# Revised Design Review Recommendation

March 19th, 2013

505 Madison St is a 36 story commercial office building with street level retail with seven levels of below grade parking. It is located on the west side of the block bounded by 5th Avenue, Madison Street, Marion Street and 6th Avenue.

BUILDING HEIGHT REDUCED FROM 38 TO 36 STORIES

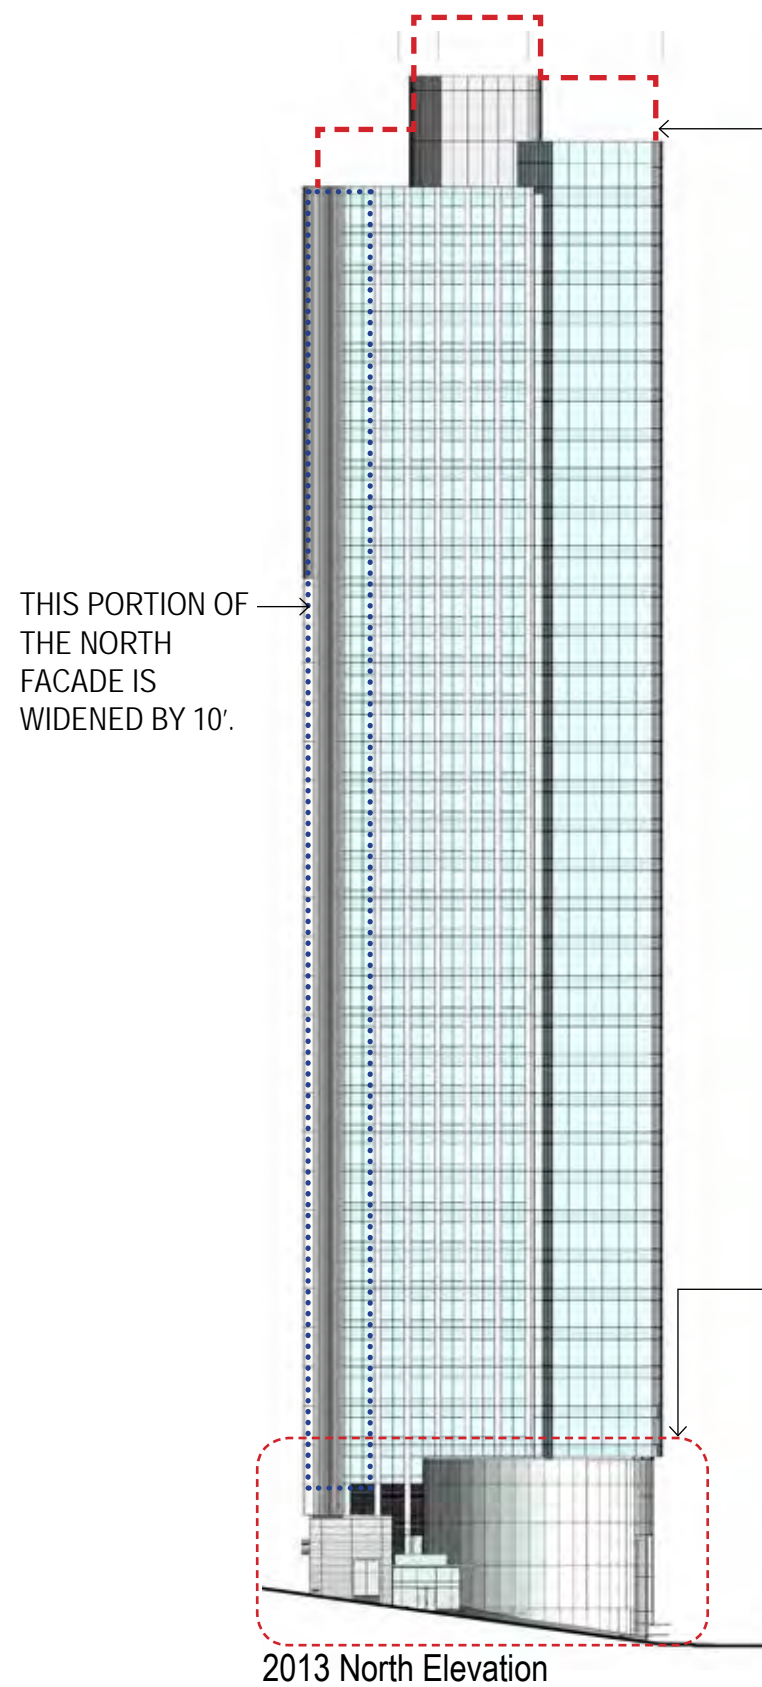
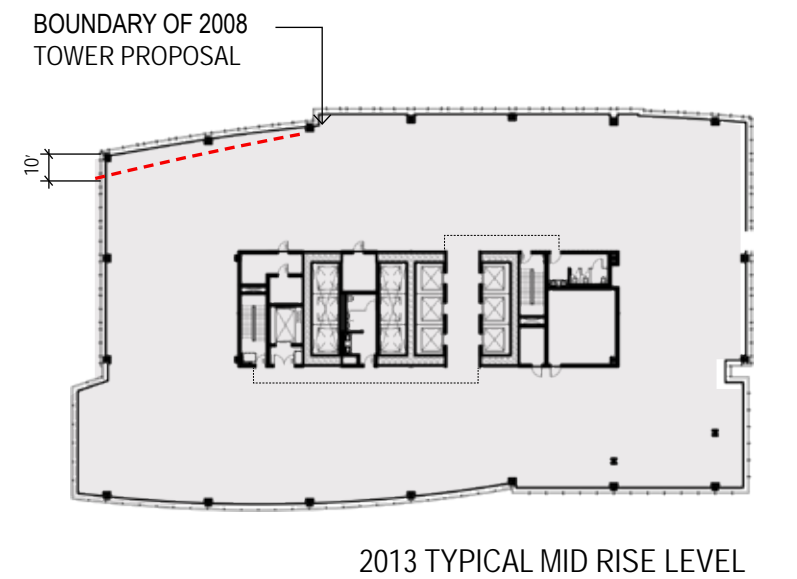
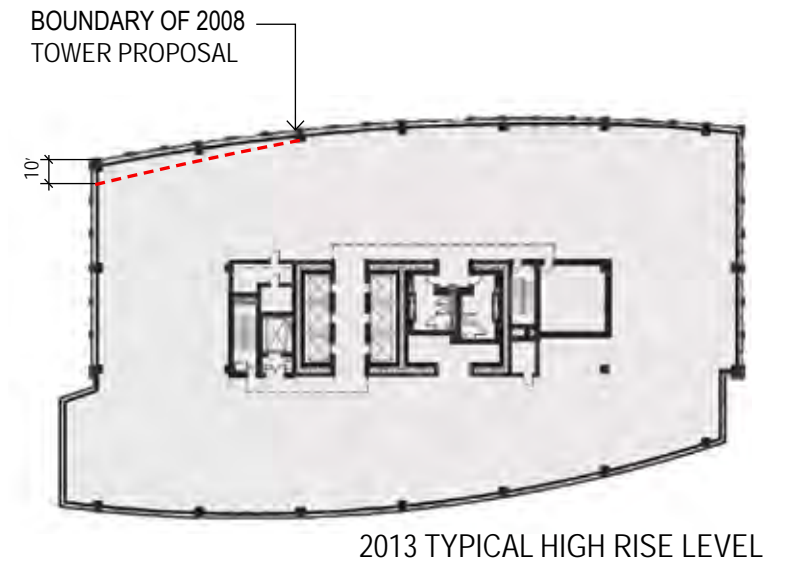
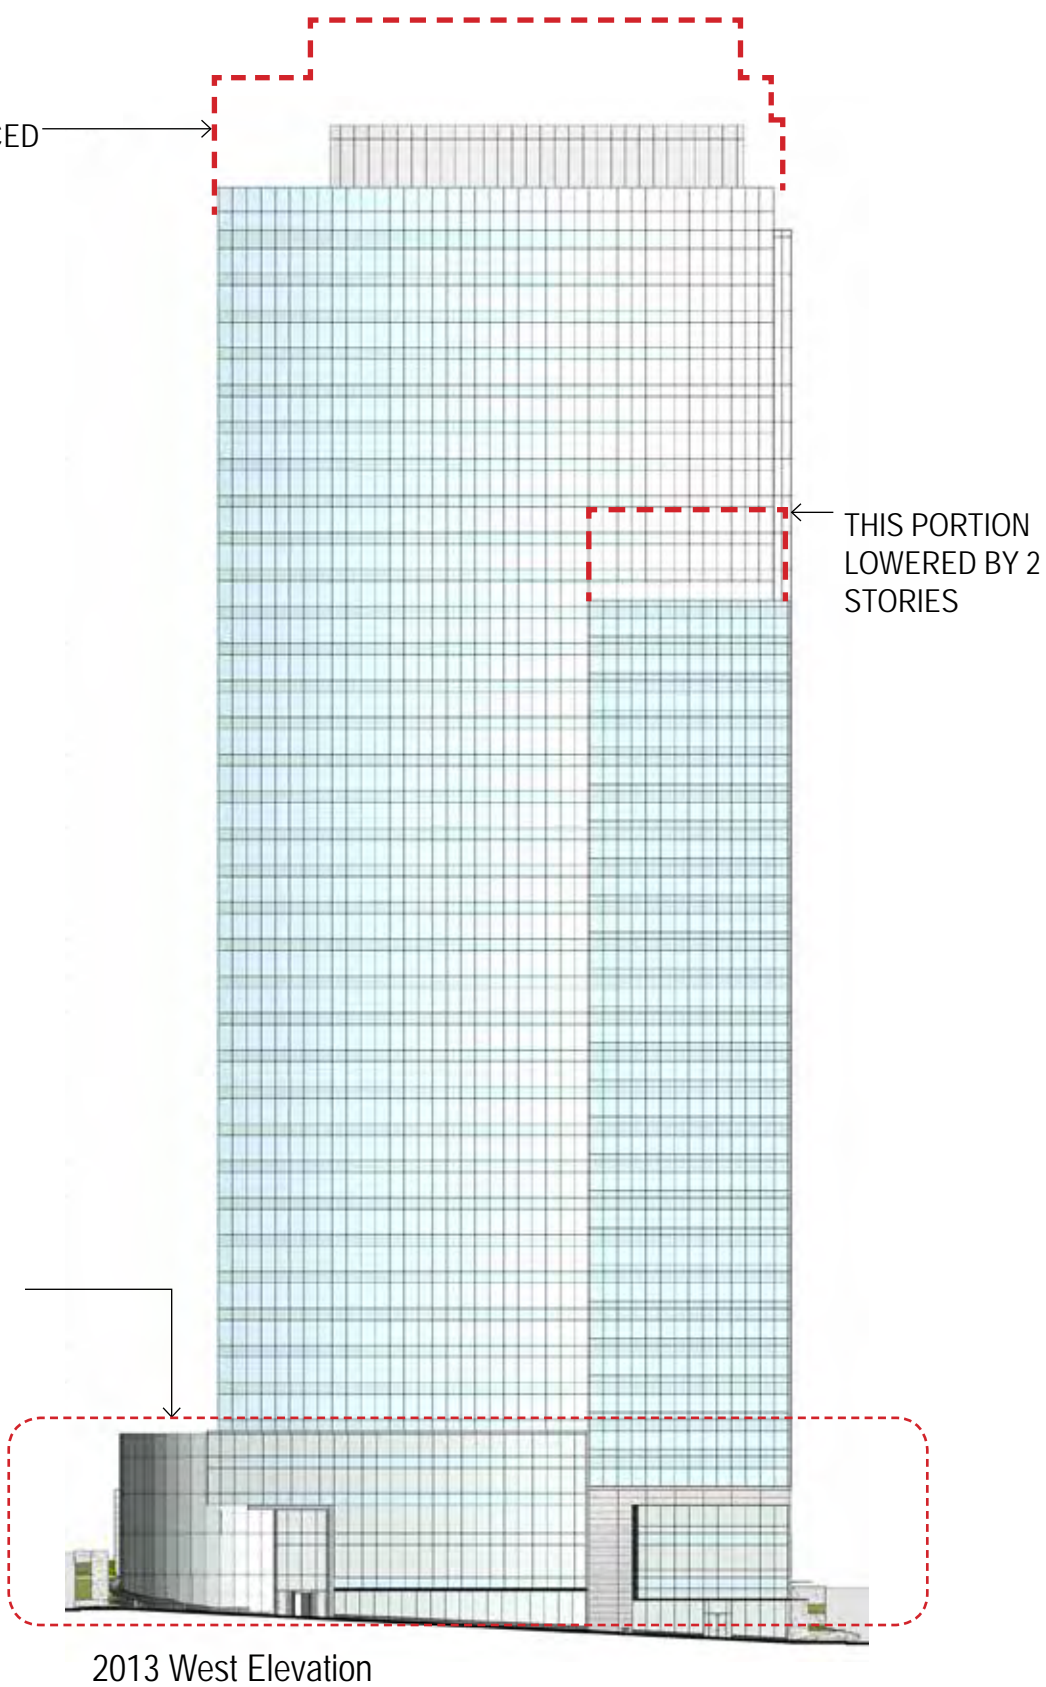
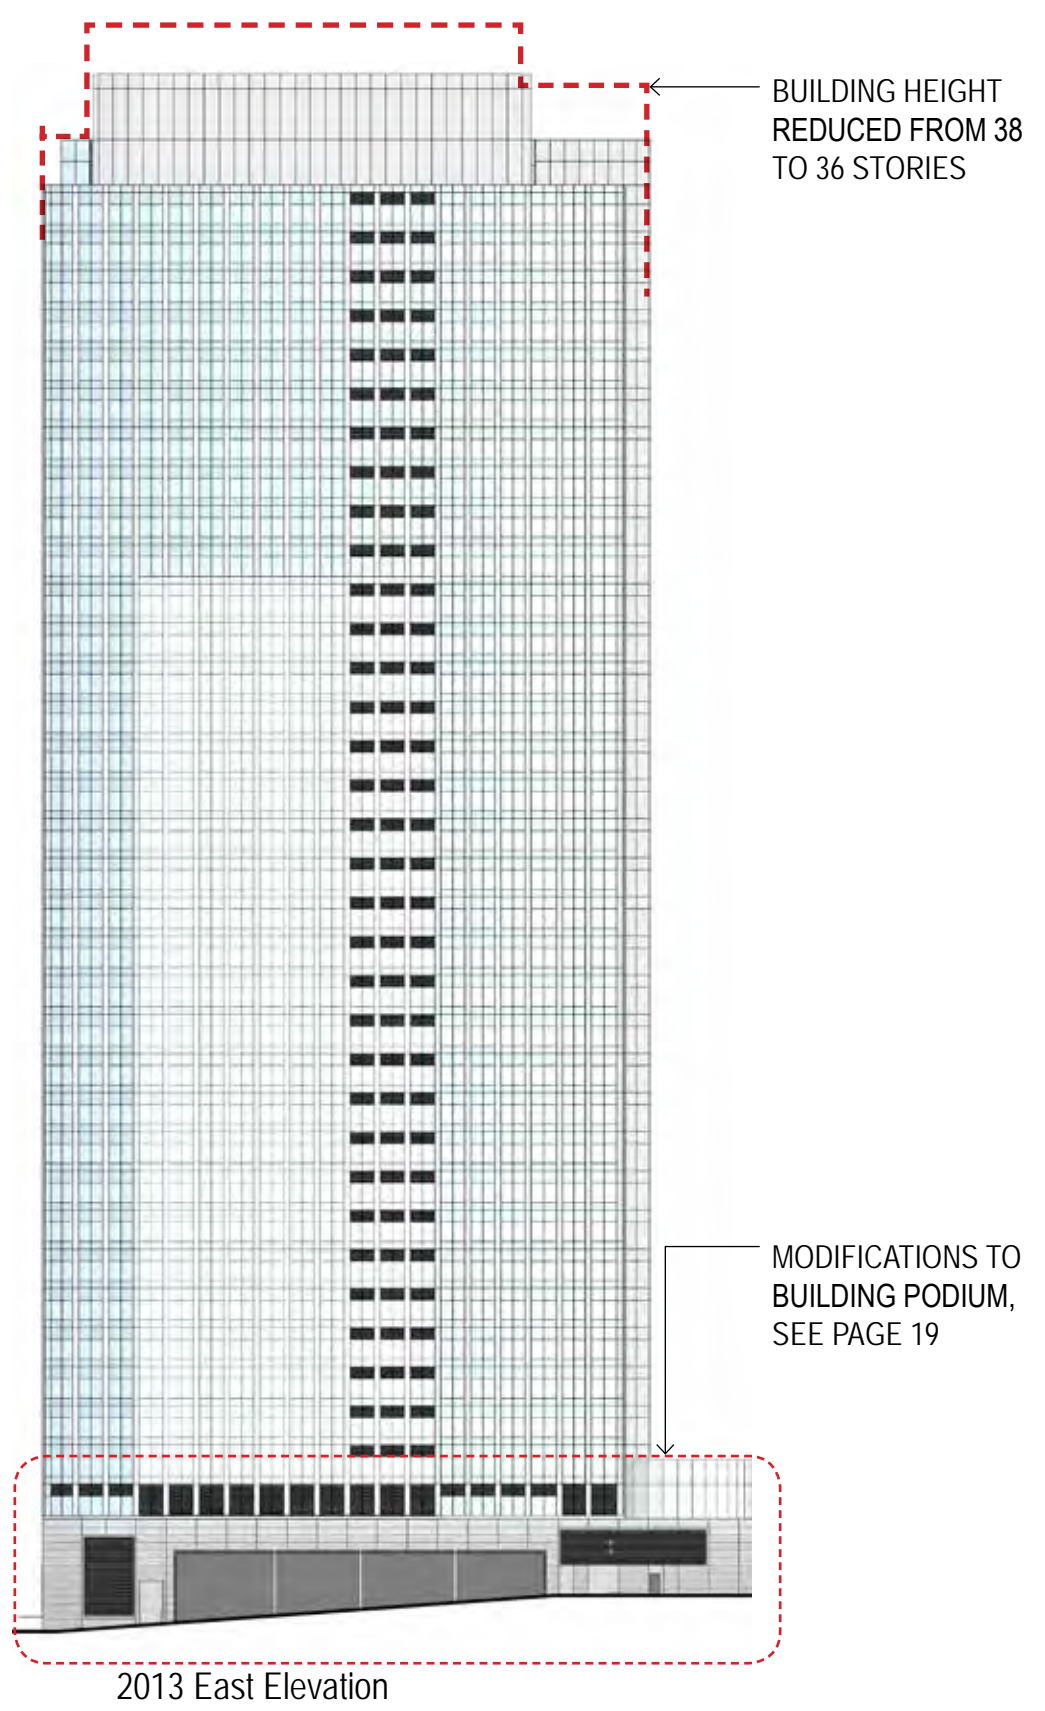
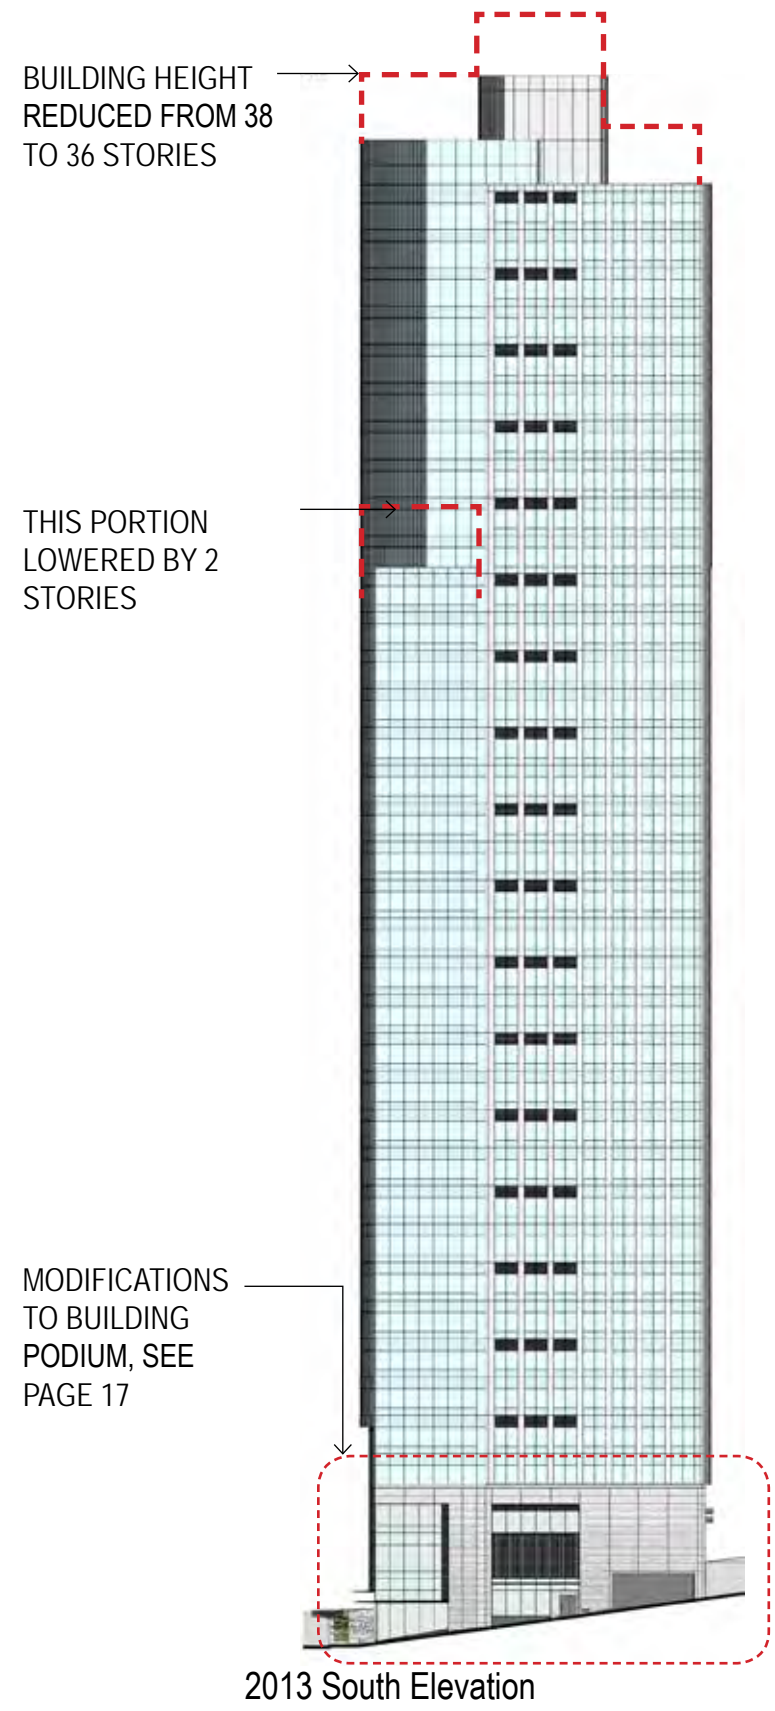
4. Office Tower is reduced from 38 stories to 36 stories and a portion of the north façade closest to the alley is widened by up to 10 feet.

3	North Façade and Office Tower Height	The north façade of the office tower has been widened by 10 feet. This was necessary to achieve the desirable floor plate size and to increase the shell to core dimension at the NW side of the building to yield a more efficient space planning dimension. This modification helps to better contrast the two major elements that compose the north facade of the building. The building has also been reduced by 2 floors from 38 floors to 36 floors.	B-1 Respond to the neighborhood context B-4 Design a well proportioned and unified building  DRB recommendation to minimize shadows cast to the Nakamura courthouse green is by achieved by reducing building by height by two stories and by placement of office tower towards the south end of the site. This reinforces design guideline B-1 to respond to the neighborhood context. Design Guideline B-4 is enhanced by slightly widening to east half of the façade to provide better contrast between the two major elements that compose the north facade of the building.
